USNRC APPLICATION
SUA-1341 License Amendment
Ludeman Project
Converse County, WY

TECHNICAL REPORT
REQUEST FOR ADDITIONAL INFORMATION
RESPONSE PACKAGE

June 2013

Path: C:\WY_Projects\8201-2013-102_Infrastructure\Project_MXD\Lueman_Water_Balance_Production_Restoration.mxd

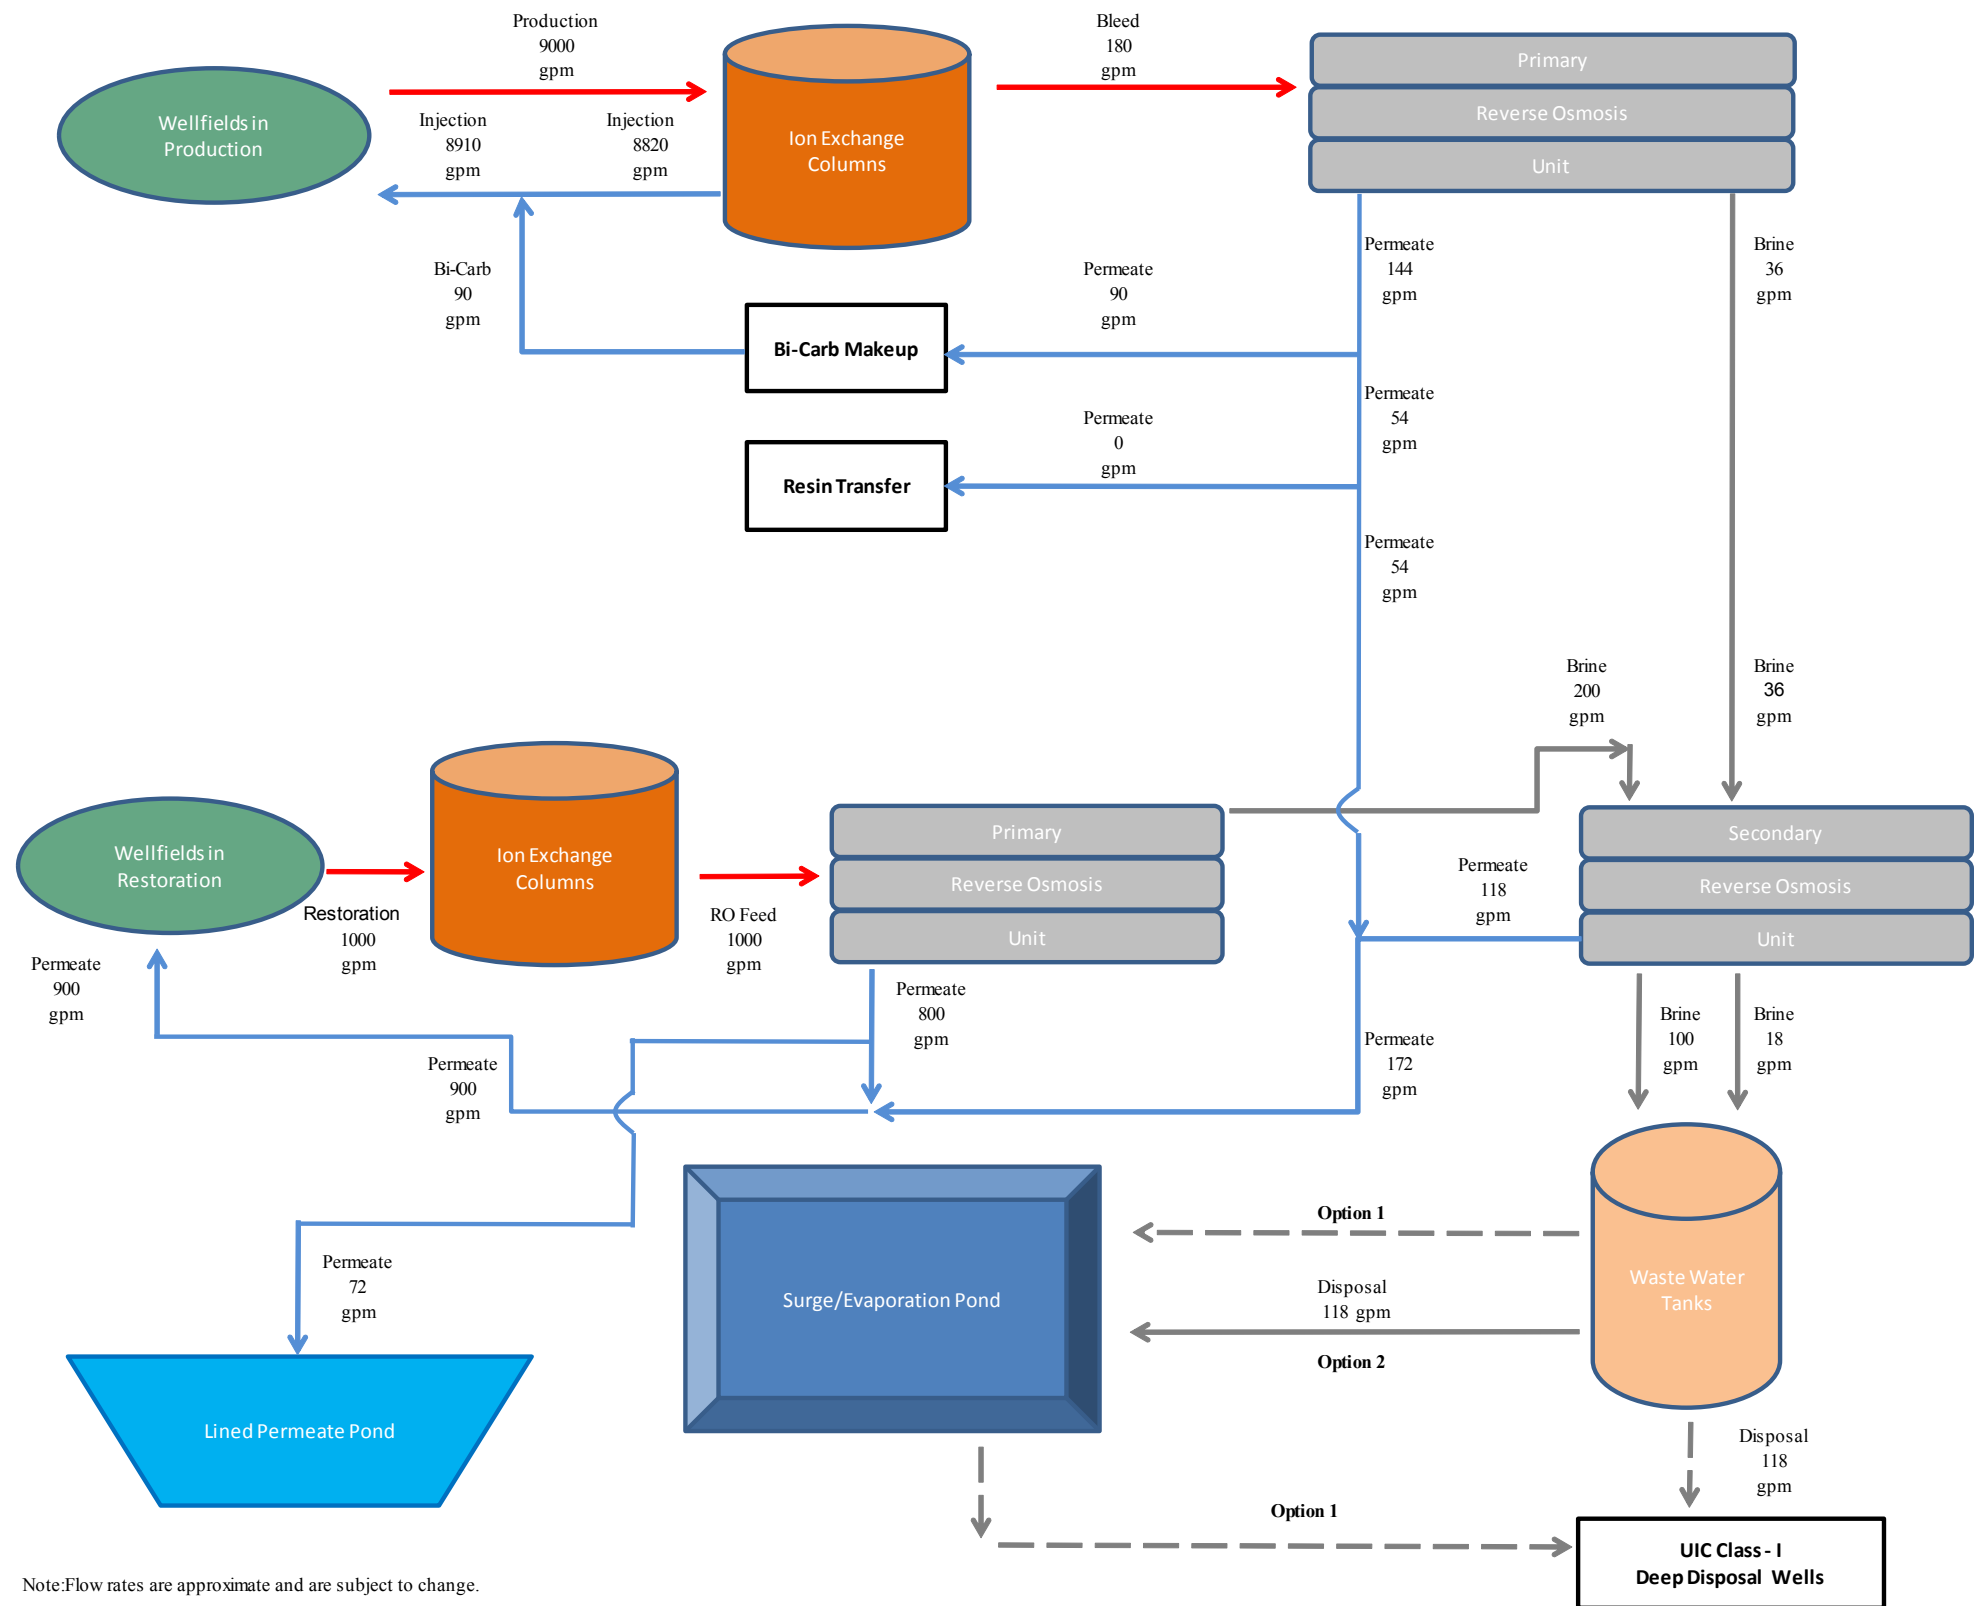
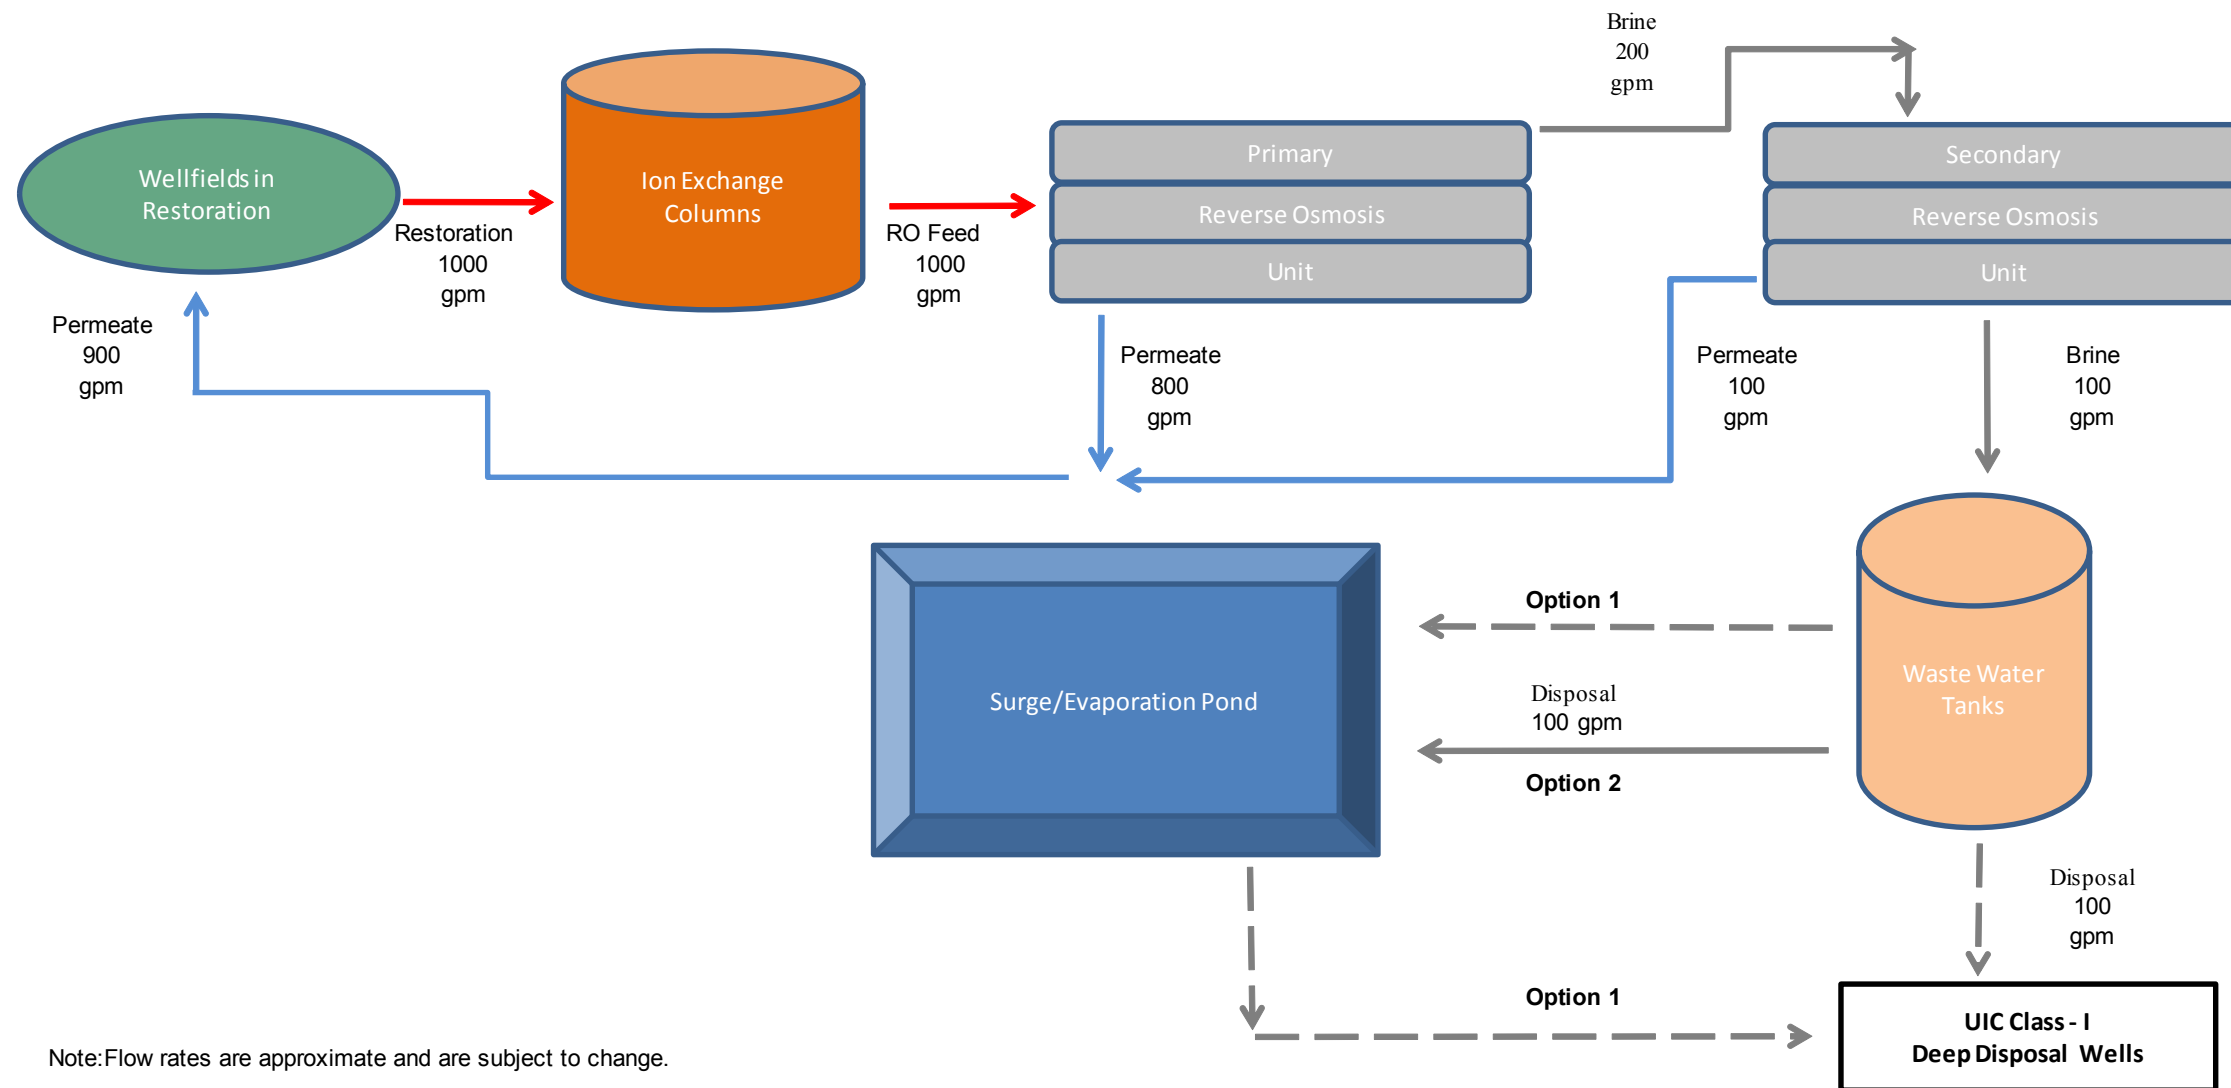
Please provide the water balance for each Project phase at each Satellite facility.

- A. Please modify Figure 3-6 of the TR to include reverse-osmosis treatment of bleed water and the flows of permeate and brine as components of the overall water balance.*
- B. Please address the potential for and volume of excess permeate during the first two years of operation before groundwater restoration begins (shown in Figure 1-4 of the ER) and clarify the proposed disposal method of this waste stream.*

Uranium One has developed new water balance figures and values to both reflect the current water balance flows and provide the NRC quantitative data in support of the environmental impact analysis. The following figures depict the water balance during all phases of the project and have been added to TR Section 4:

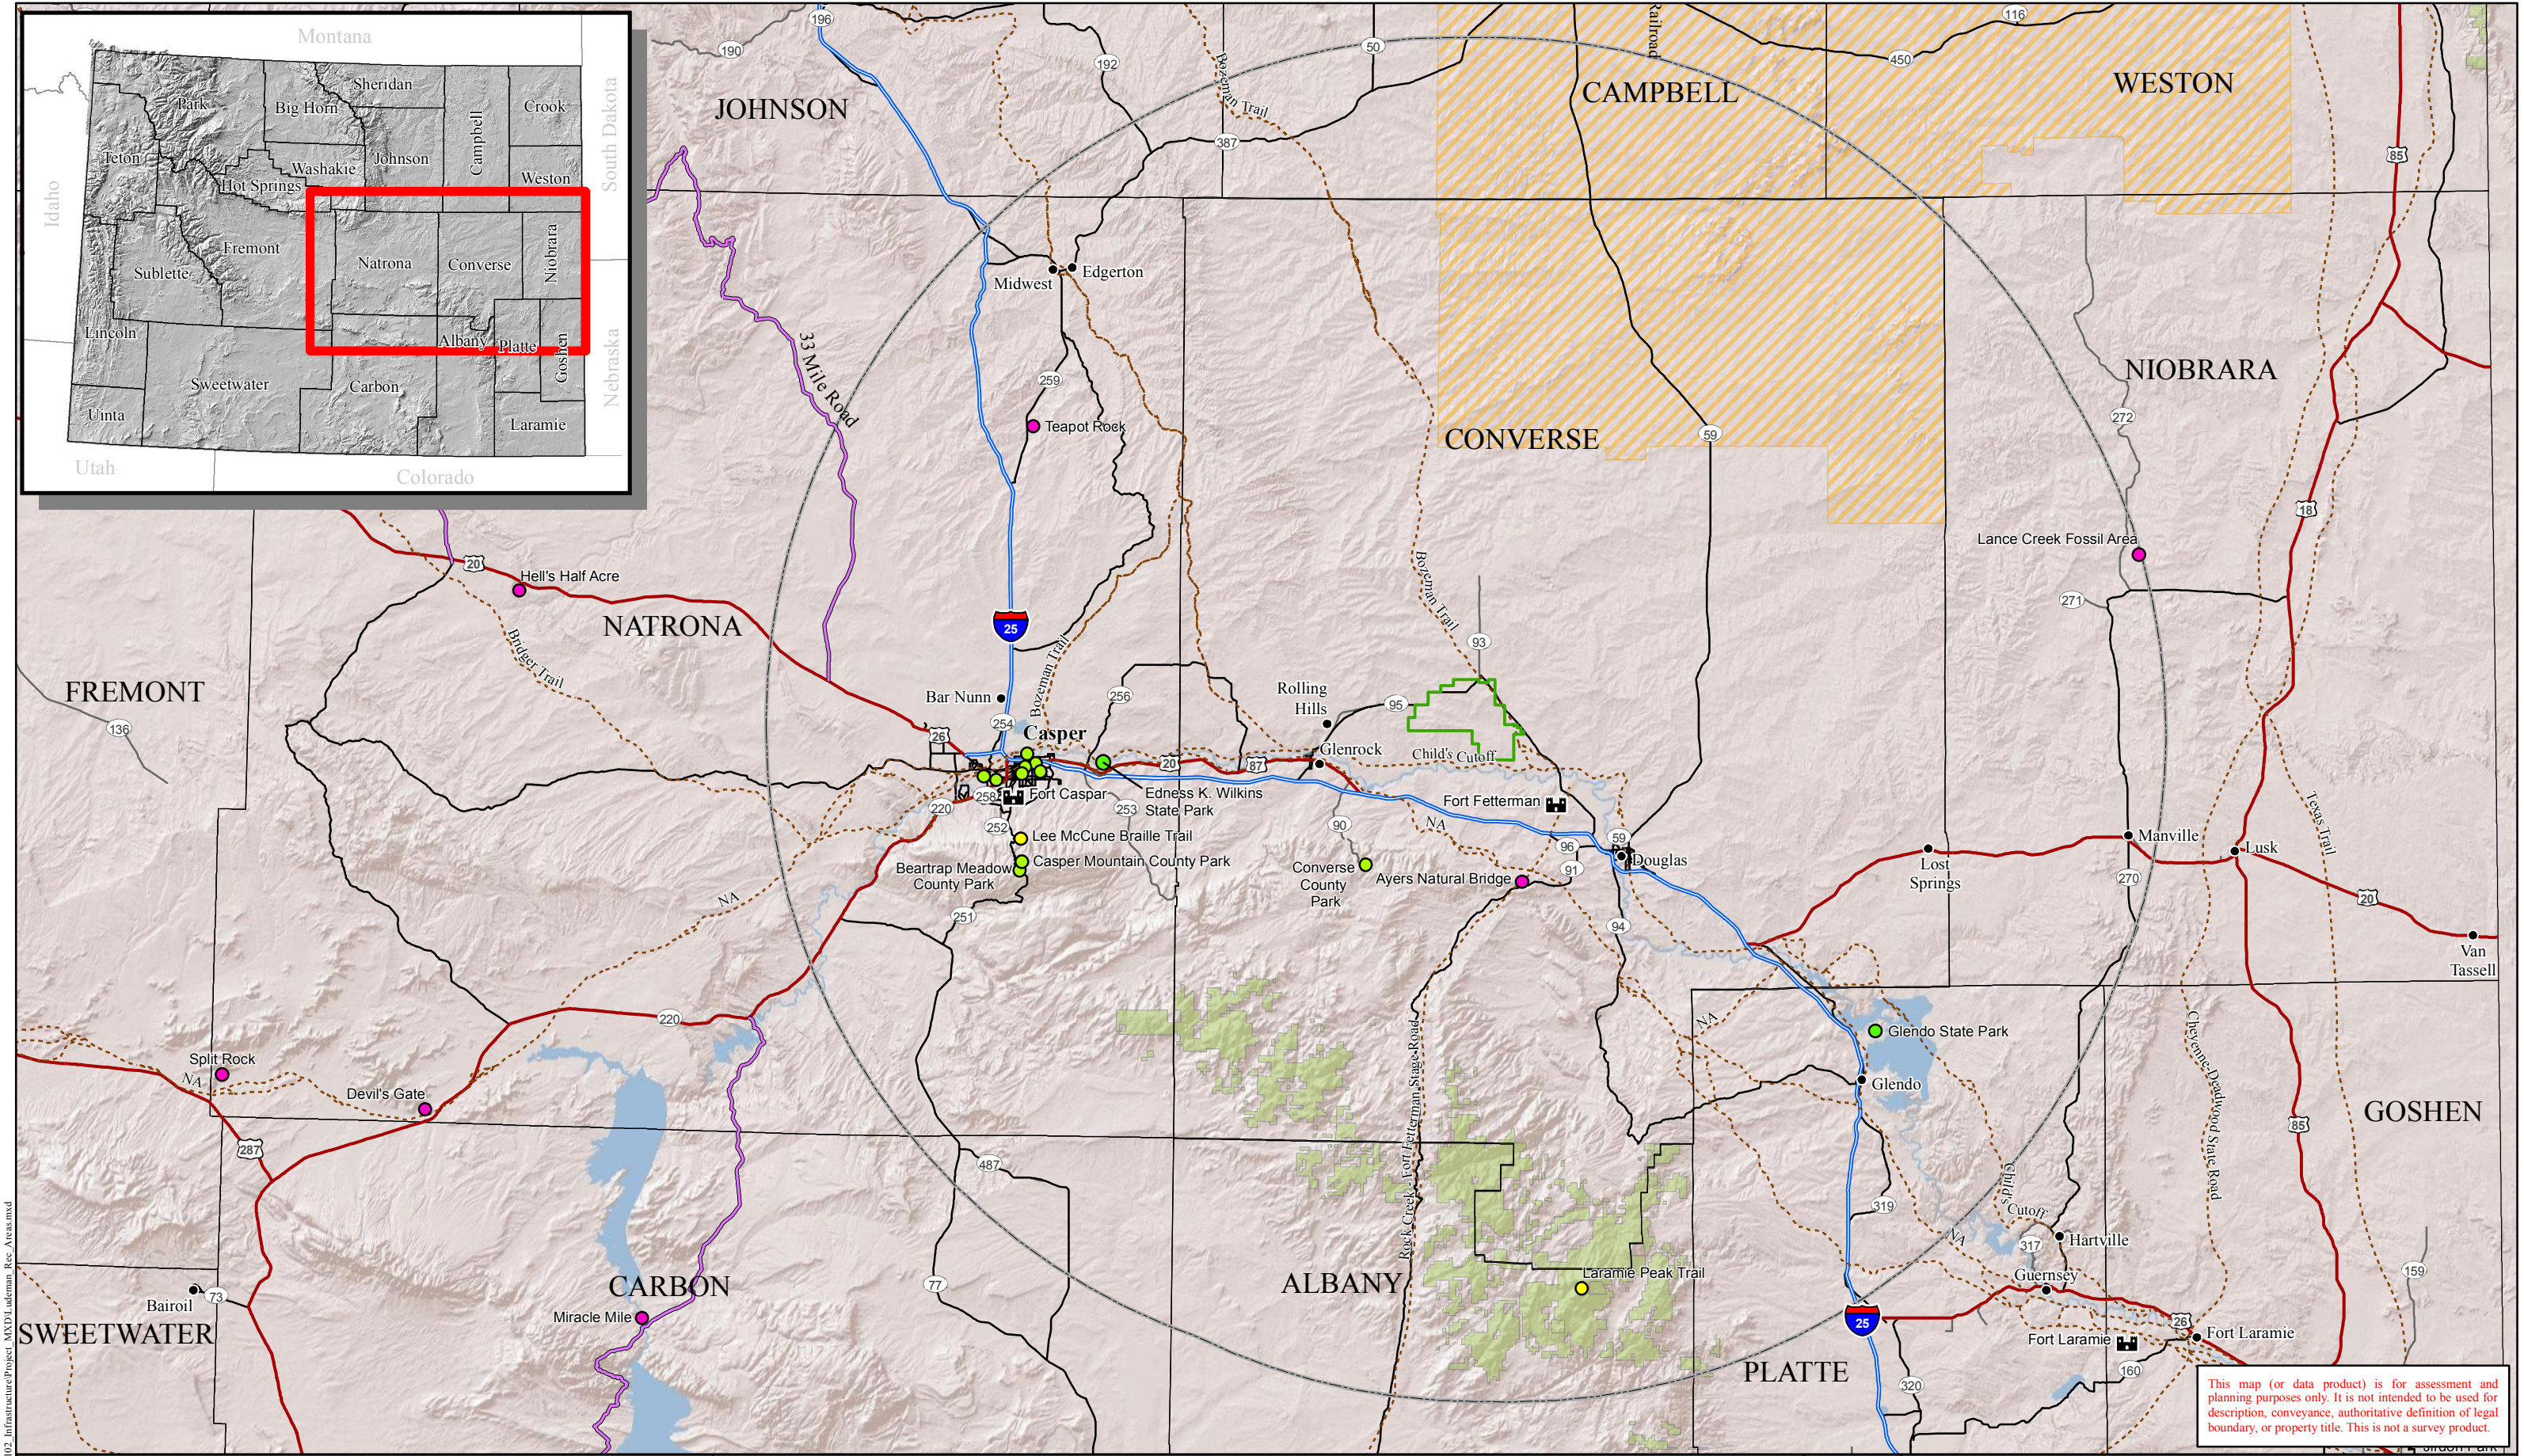
Please clarify the location and use of recreational lands within the Ludeman Project and the surrounding area.

- A. Please provide a map showing the location of recreational areas and trails (e.g., the Child's Cutoff Trail) on the Ludeman Project and in the surrounding area.*
- B. Please specify whether hunting occurs on Federal or State lands within the Project boundaries.*
- C. Please discuss the impacts to recreational areas from the proposed Ludeman Project.*

To better facilitate the NRC's characterization of existing land uses and potential recreational impacts a map of recreational areas and trails in the vicinity of the proposed project will be inserted in ER Section 3 and is provided below.
